BRADLEY POINT FILING NO. 1

CONSTRUCTION PLANS

BRADLEY POINT FILING NO. 1
COVER SHEET

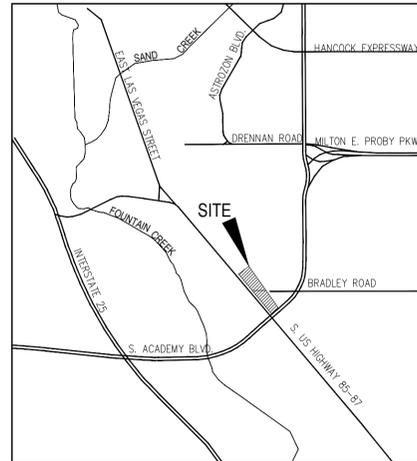
I would add a note that CDOT requirements apply at the access to HWY 85.

STRIPING AND SIGNAGE PLAN

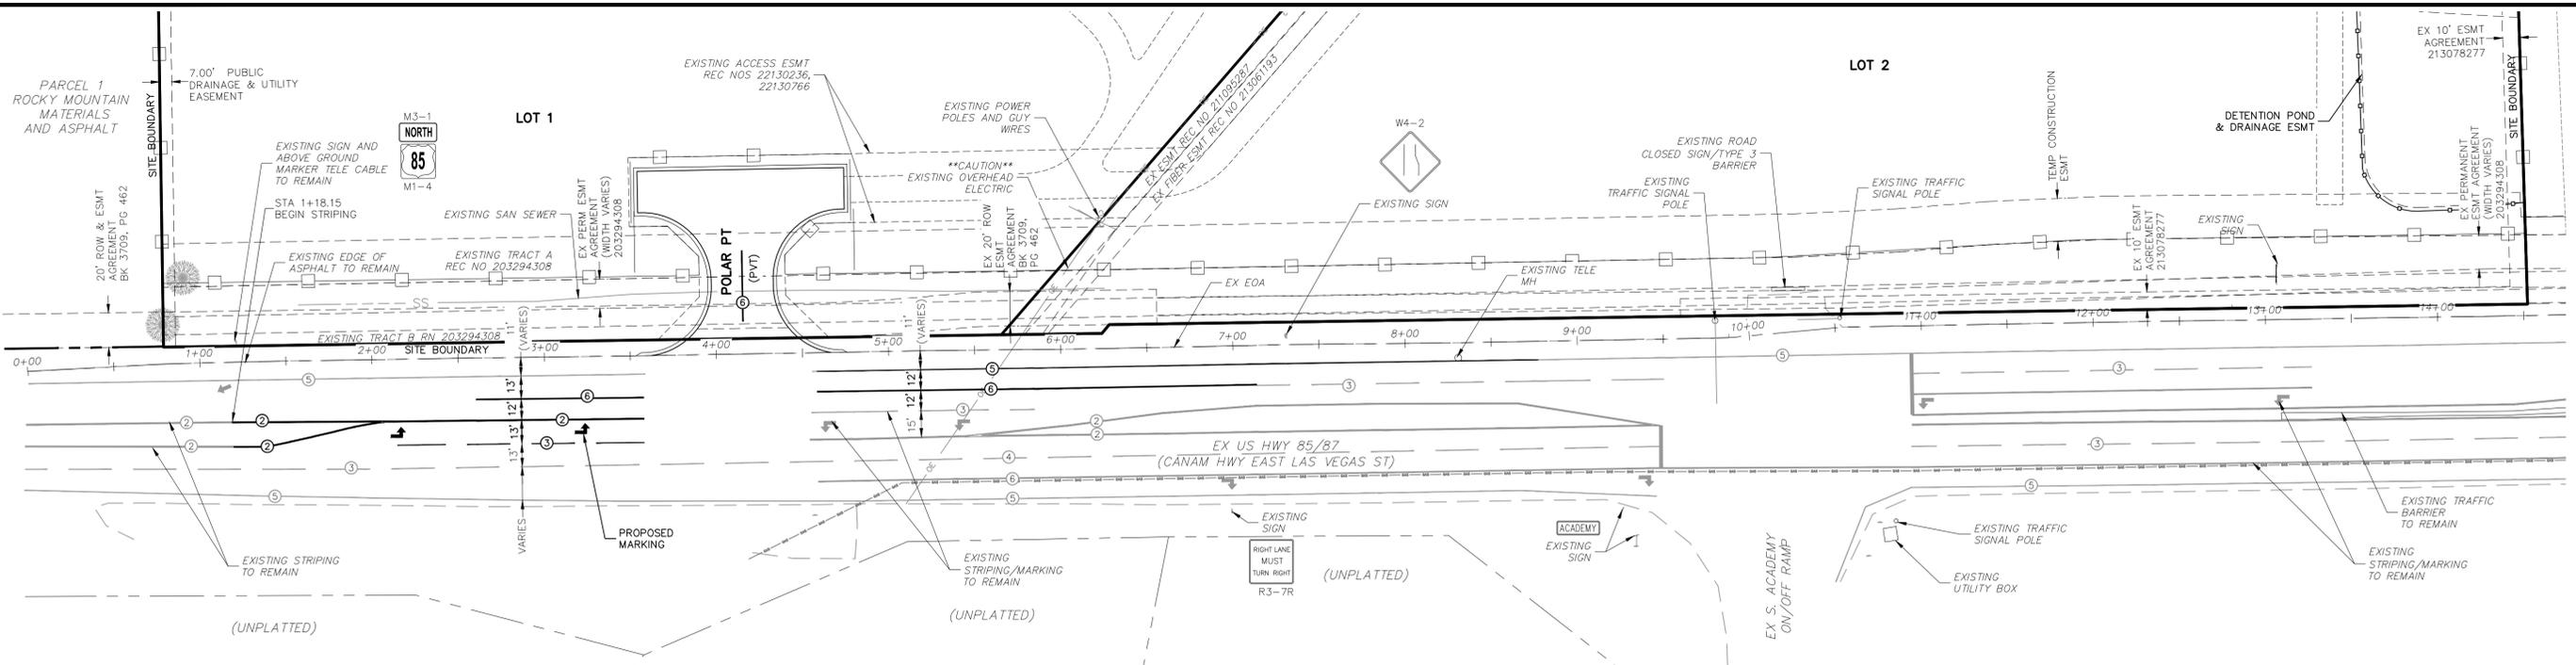
For information only / CDOT approval required
